PROPOSED REVISION 15
AP1000 DESIGN CONTROL DOCUMENT

Tier 1 Subsection 2.1.3; Tables 2.1.3-1, 2.1.3-2, 2.1.3-3, and 2.1.3-4; and Figure 2.1.3-3
Reactor System

Tier 2 Tables 1.3-1 and 5.3-5; Subsections 5.3.1.2 and 5.3.4.1; and Figures 5.3-1 and 5.3-6
Reactor Vessel

Description of Change

Figure 2.1.3-3
Reactor Vessel Arrangement

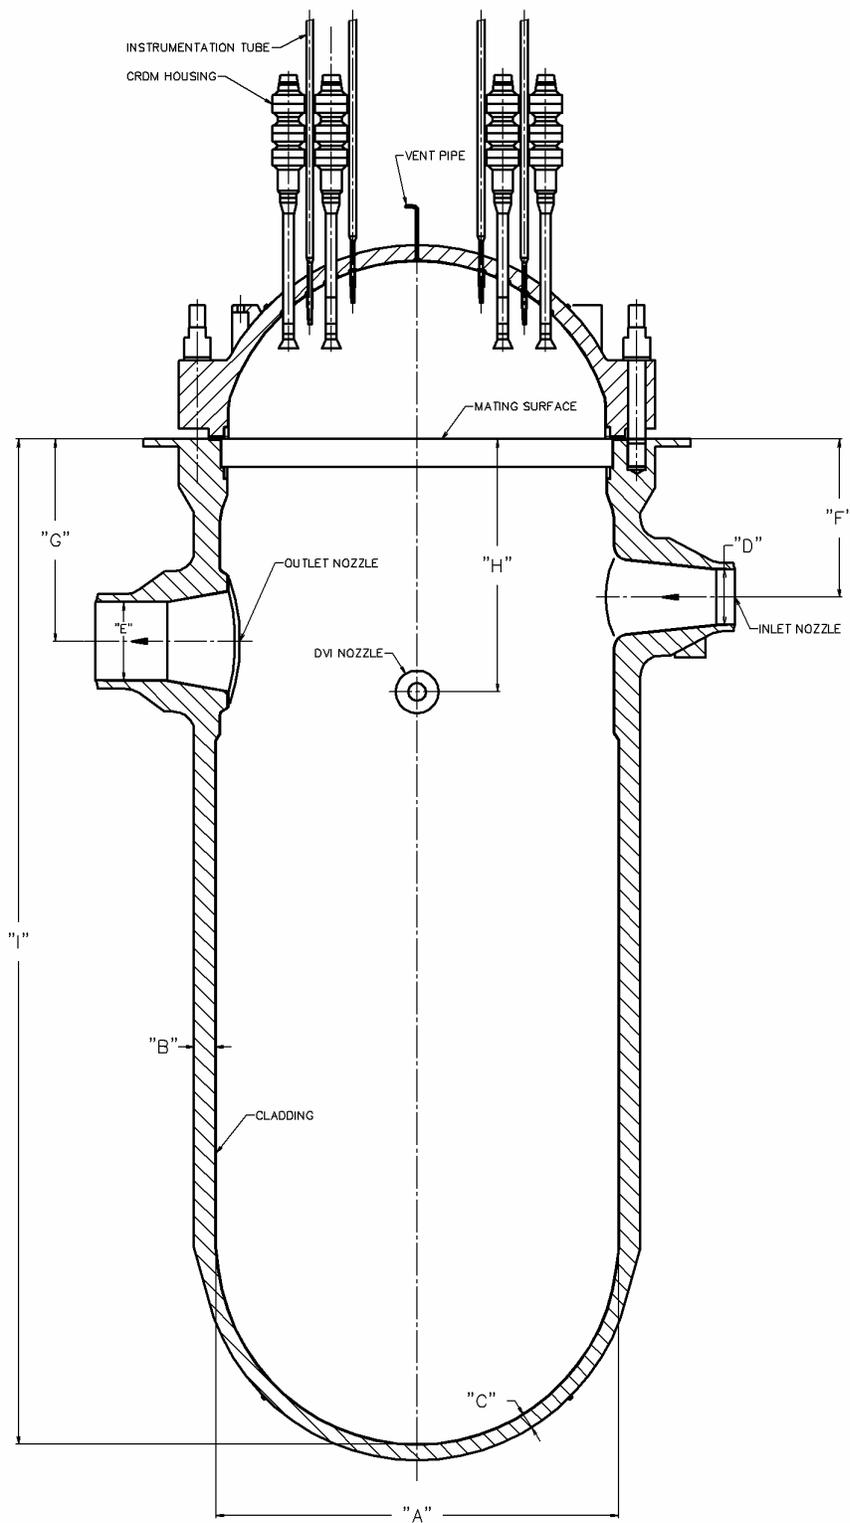
Table 2.1.3-4 Key Dimensions and Acceptable Variations of the Reactor Vessel and Internals (Figure 2.1.3.2 and Figure 2.1.3-3)			
Description	Dimension or Elevation (inches)	Nominal Value (inches)	Acceptable Variation (inches)
RV inside diameter at beltline (inside cladding)	A	159.7.0	+1.0/-1.0
RV wall thickness at beltline (without cladding)	B	8.48.0	+1.0/-0.12

Tier 1 Figure 2.1.3-3 Revise Tier 1 Figure 2.1.3-3 as shown on the next page.

Figure 5.3-1

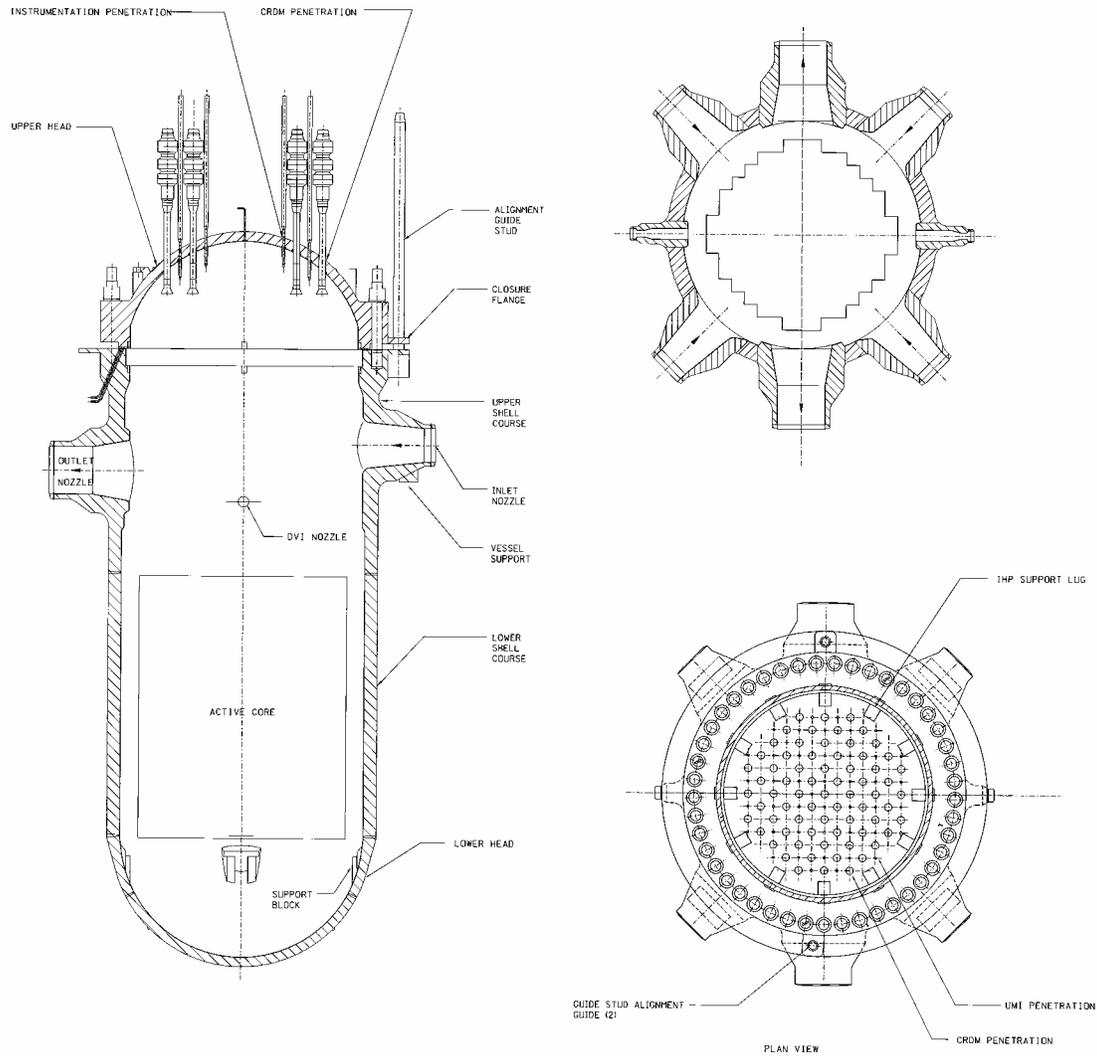
The reactor vessel consists of a cylindrical section with a [transition ring](#), hemispherical bottom head, and a removable flanged hemispherical upper head (Figure 5.3-1). Key dimensions are shown in Figures 5.3-5 and 5.3-6. The cylindrical section consists of two shells, the upper shell and the lower shell. The upper and lower shells and the lower hemispherical head are fabricated from low alloy steel and clad with austenitic stainless steel. The upper shell forging is welded to the lower shell forging and the lower shell is welded to the [transition ring, which is welded to the](#) hemispherical bottom head. The removable flanged hemispherical upper head consists of ~~two sections,~~[a single forging, which includes](#) the closure head flange and the closure head dome. The closure head ~~flange and dome are~~[is](#) fabricated from a low alloy steel forging ~~and plate respectively,~~ and clad with austenitic stainless steel. Specifics of the processes used in base materials, clad material, and weld materials are discussed in subsection 5.2.3. The removable flanged hemispherical closure head is attached to the vessel (consisting of the upper shell-lower shell-bottom hemispherical head) by studs. Two metal o-rings are used for sealing the two assemblies. Inner and outer monitor tubes are provided through the upper shell to collect any leakage past the o-rings. Details of the head gasket monitoring connections are included in subsection 5.2.5.2.1.

Four core support pads are ~~welded to~~[located on](#) the bottom hemispherical head just below the ~~bottom hemispherical head~~[transition ring](#)-to-lower shell circumferential weld. The core support pads function as a clevis. At assembly, as the lower internals are lowered into the vessel, the keys at the bottom of the lower internals engage the clevis in the axial direction. With this design, the internals are provided with a lateral support at the furthest extremity and may be viewed as a beam supported at the top and bottom.

Figures 5.3-1 and 5.3-6 Revise Figures 5.3-1 and 5.3-6 as shown on the following pages.

Figure 5.3-6

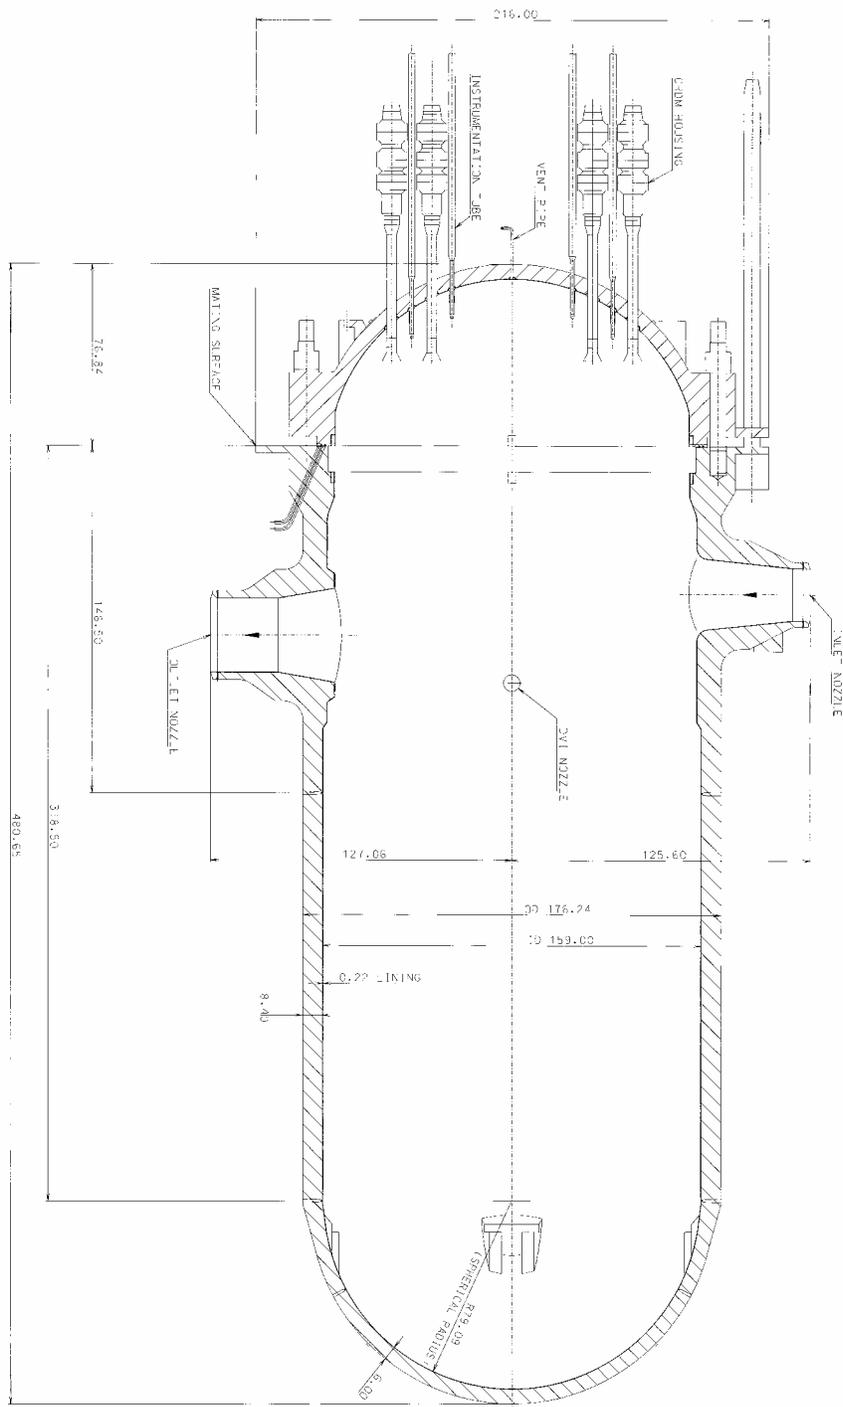
Most of the changes reflect current fabrication practices; for example, a one-piece forged reactor vessel head is the standard replacement head configuration. The increase in vessel inside diameter in the core region by 2 inches helps to decrease the fluence on the vessel. The decrease in the vessel wall thickness near the nozzles makes welding the nozzles easier, and the resulting wall thickness is the same as in the Westinghouse Standard 3XL reactor vessels.

The reactor vessel (including closure head) is approximately 40 feet long and has an inner diameter at the core region of ~~157-159~~ inches. The total weight of the vessel (including closure head and CRDMs) is approximately 417 tons. Surfaces which can become wetted during operation and refueling are clad to a nominal 0.22 inches of thickness with stainless steel welded overlay which includes the upper shell top surface but not the stud holes. The AP1000 reactor vessel's design objective is to withstand the design environment of 2500 psi and 650°F for 60 years. The major factor affecting vessel life is radiation degradation of the lower shell.
